AMENDMENT OF SOLICITATION/MODIFICATION OF CONTRACT

1. The specifications and drawings for Invitation No. DACW64-02-B-0028, Lynchburg Pumping Station, Hurricane-Flood Protection, Houston Ship Channel, Texas, advertised 2 July 2002, and for which bids are to be opened on 1 August 2002, are hereby modified as follows:

(To Accompany Amendment No. 0002 to Invitation No. DACW64-02-B-0028)

THIS ATTACHMENT ACCOMPANIES AMENDMENT NO. 0002
TO CONTRACT NO. DACW64-02-B-0028.

TYPICAL SECTION A - A

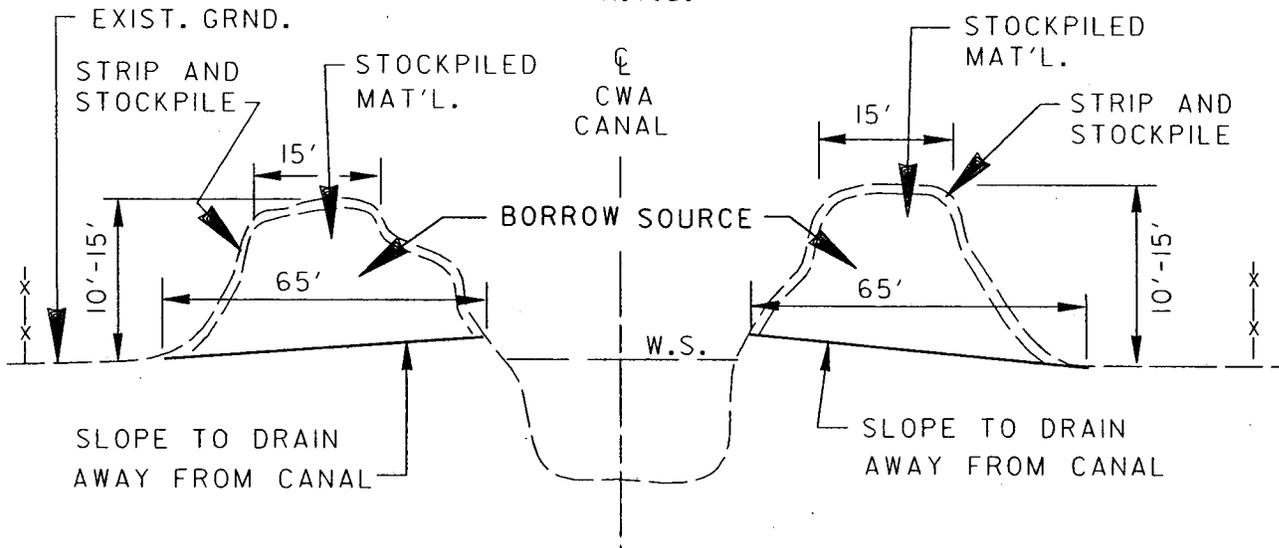
(1) Drawing No. C-1. - Change the spelling of "RESERVIOR" TO "RESERVOIR."
Delete the "CWA BORROW AREA" just North of WALLISVILLE ROAD. Also, the enclosed ATTACHMENT NO. 1, TYPICAL SECTION, shall be added to this drawing, which revises the location of "CWA BORROW AREA" North of WALLISVILLE ROAD.
